## Product Change Notification

**1. ECR #:** 25-38569-1  
**Notification #:** 803

- BCS-1XX-XXX-D-HE-XXX - null
- SSM-1XX-XXX-DH-XX-XX-XX-X-XX - null

**4. Part #'s Affected**

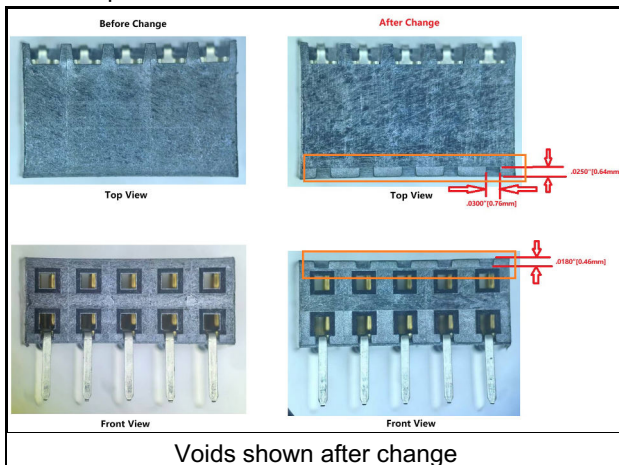
Add voids across the top front area of body, void size is about 0.76 x 0.64 x 0.46 mm.

Add voids (about 0.76 x 0.64 x 0.46 mm) to improve resin reflow and body manufacturing stability, no functional concern. This will be a rolling change.

- Form - This will be an appearance difference.
